AGENDA PACKET

FEBUARY 28, 2023 MEETING

RE: Waccabuc Beach Club Improvements
Waccabuc Country Club
Perch Bay Road
Sheet 25A, Block 10813, Lot 1
Sheet 25, Block 11155, Lot 148

RE: Beach Club Improvements Project
Waccabuc Country Club
Perch Bay Road
Waccabuc, NY
TM# Block 11155, Lot 148, Sheet 25 and Block 10813, Lot 01, Sheet 25A

ENLARGED MICROPOOL EXTENDED DETENTION POND PLAN

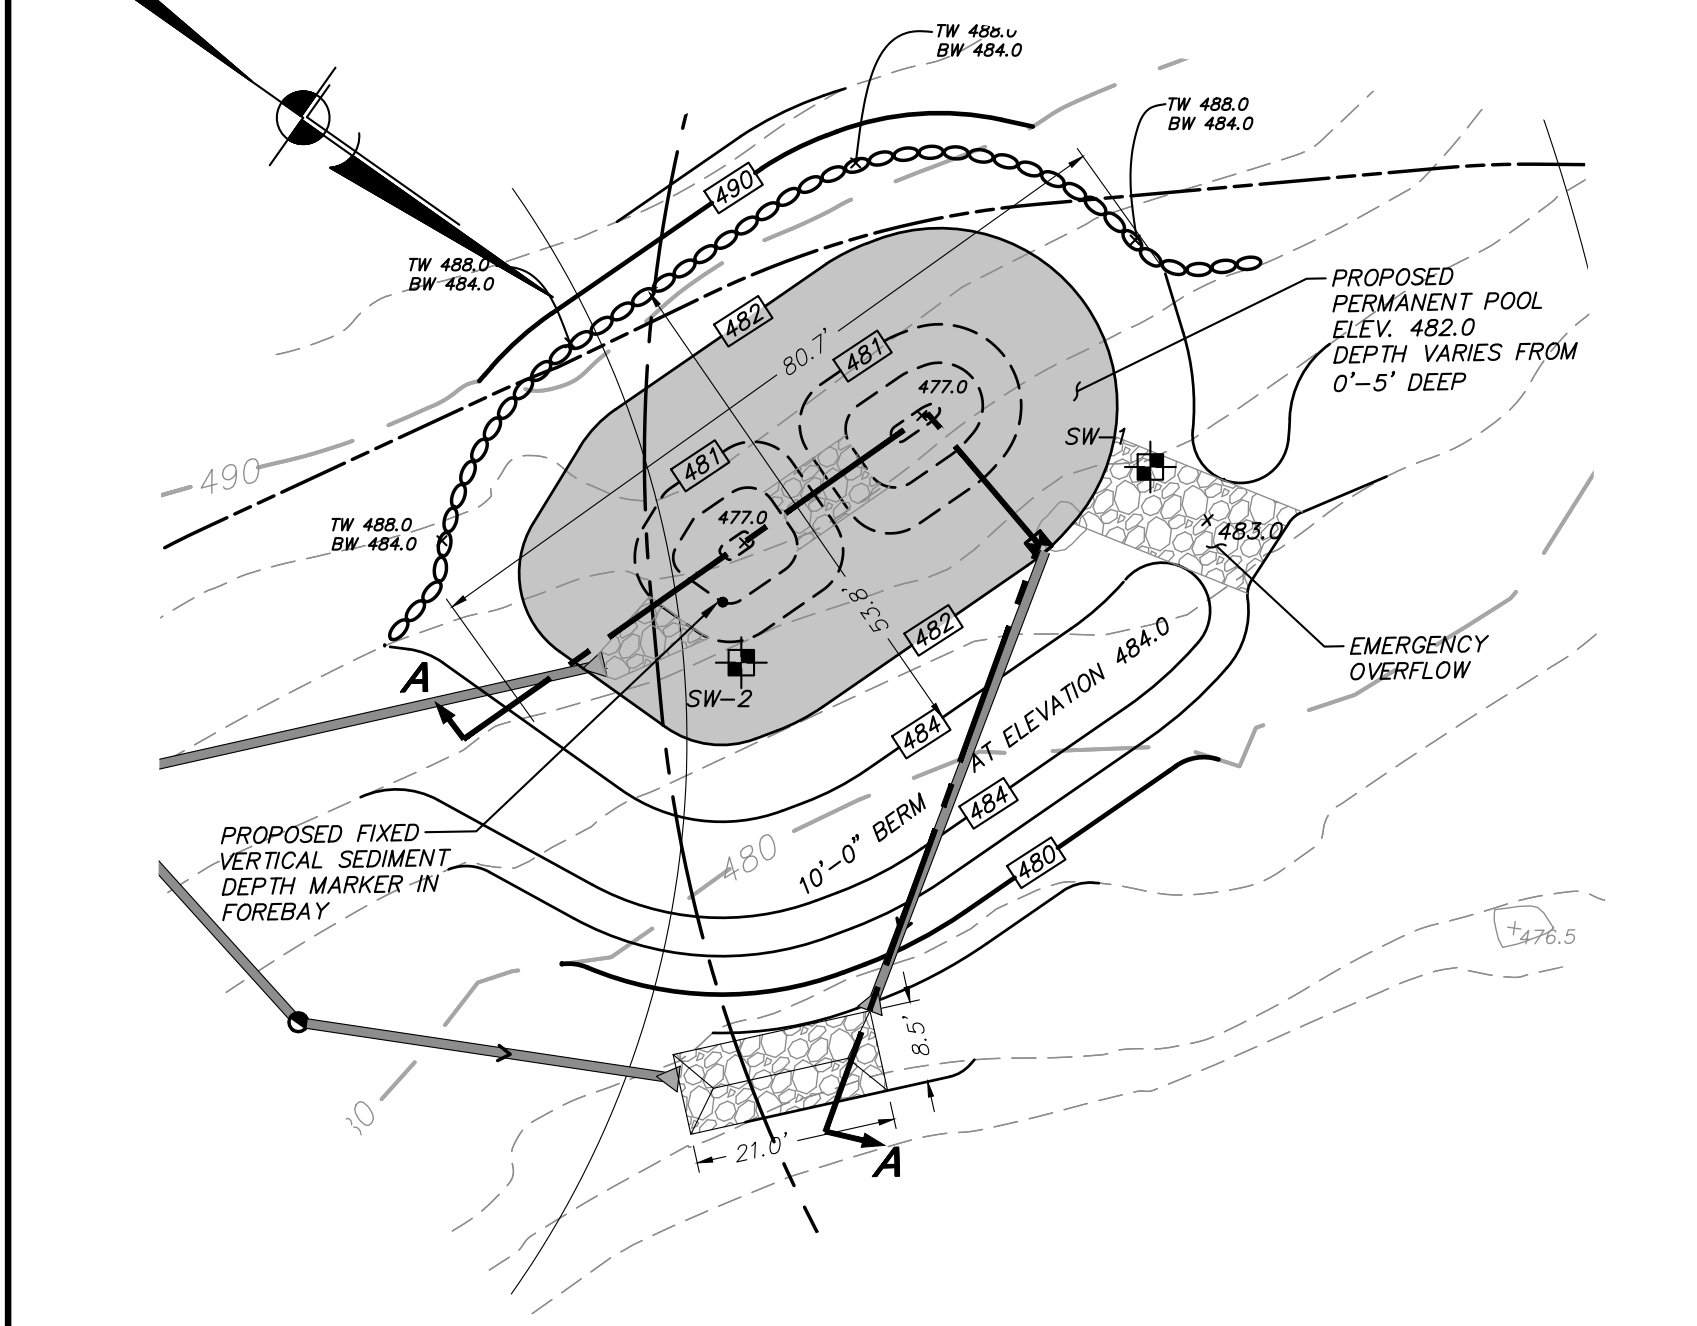
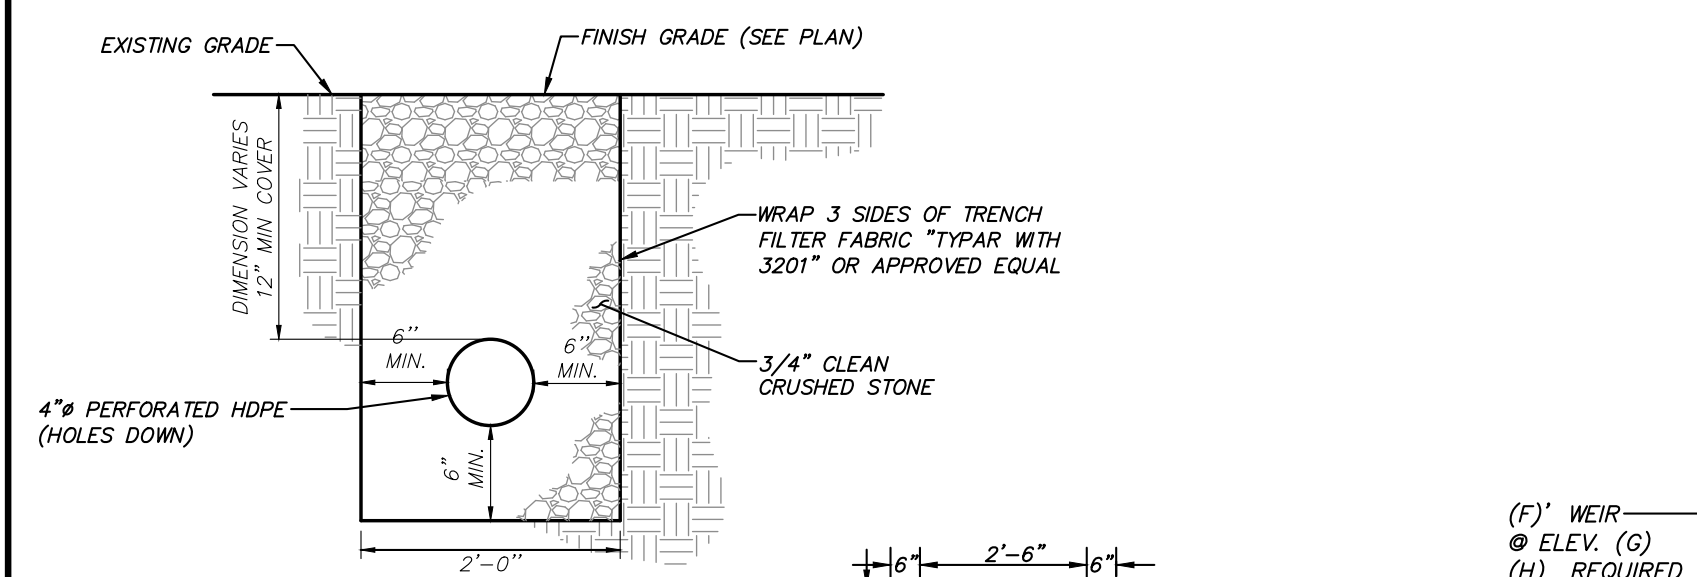
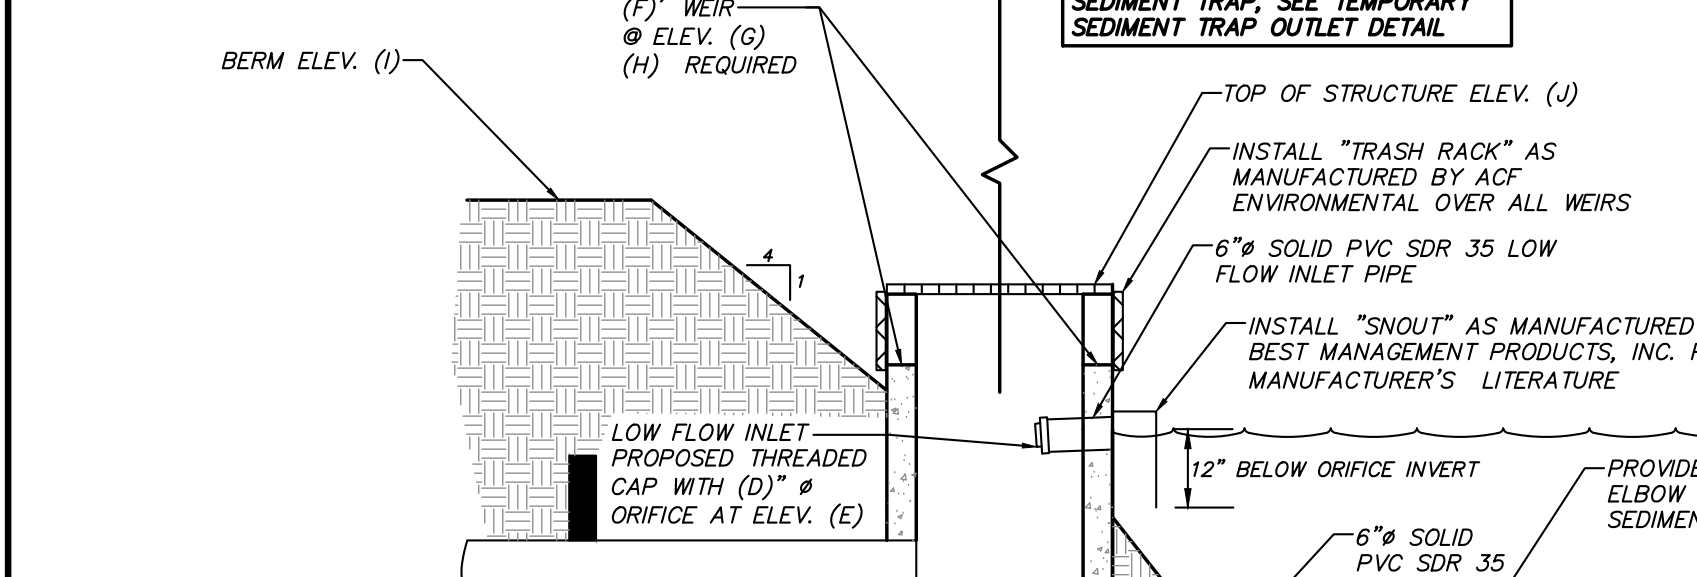
6. Include the pond drain elevation(C) for the micro pool detention pond on the plans. Using a sump pump to fully dewater the pond in the event of future maintenance shall be noted on the pond detail.

10. Provide a call-out for the aquatic bench on the enlarged pond plan. The aquatic bench as it appears on the landscape plan should be located around the forebay and micropool separately as shown in the Design Manual. Indicate whether these plants are suitable enough to withstand the groundwater conditions in the proposed area of the pond.

11. Based on the detail provided for the temporary sediment trap and the groundwater elevation shown on the profile, explain what storage will be available in order to use it as temporary erosion control practice.

LEVEL SPREADER DETAIL

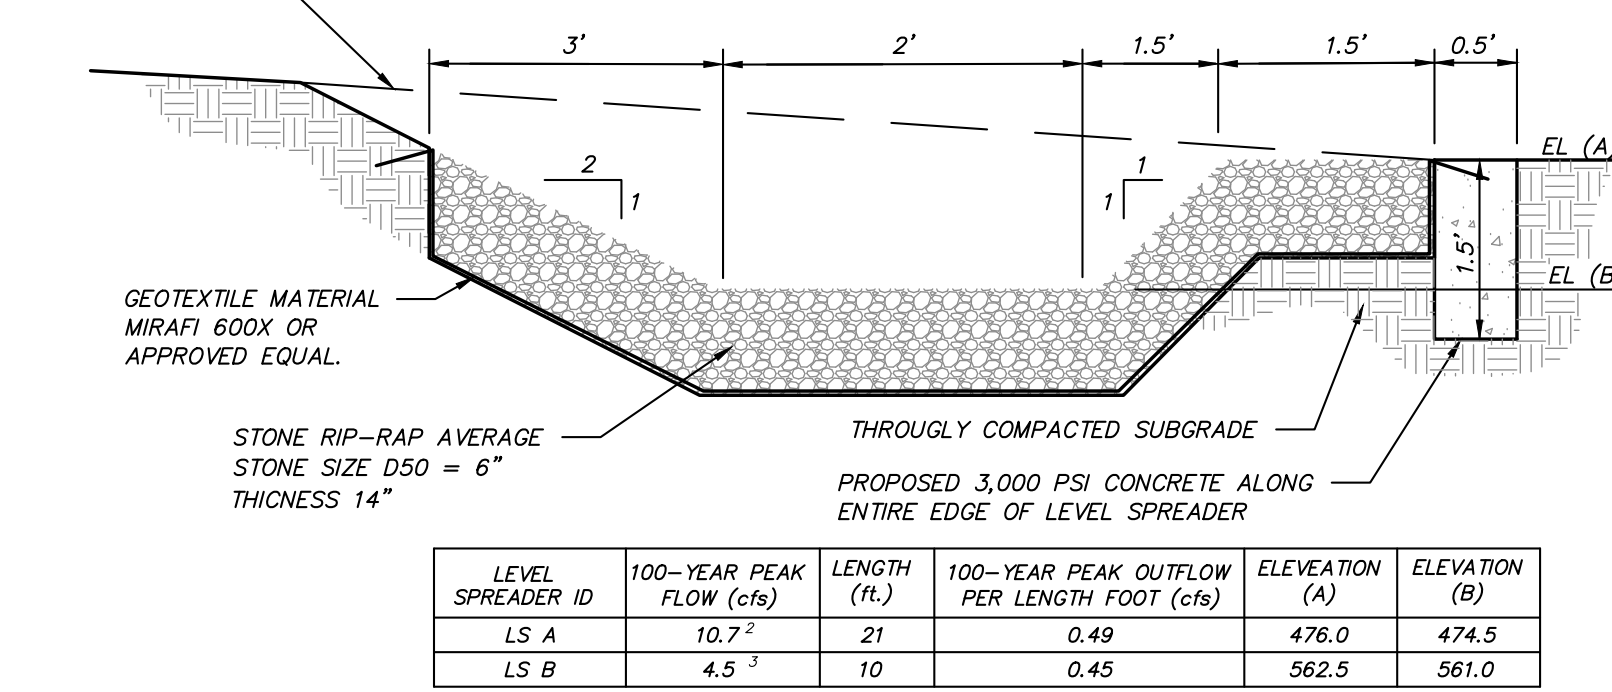
7. Locate level spreader B on the plan. No level spreader is shown at ES9B, inflow point to the P-1 Pond. Explain why a level spreader is chosen at the inflow point instead of a Rock Outlet Protection(ROP). Also, an ROP for the cistern overflow shall be included on the plans as requested in the previous comment letter.

8. A significant amount of flow enters the level spreader A at ES2 from sides and therefore a uniform flow distribution will not be possible as mentioned in the Blue Book. Revise the orientation of the pipe outlet so that these lateral flows are avoided.
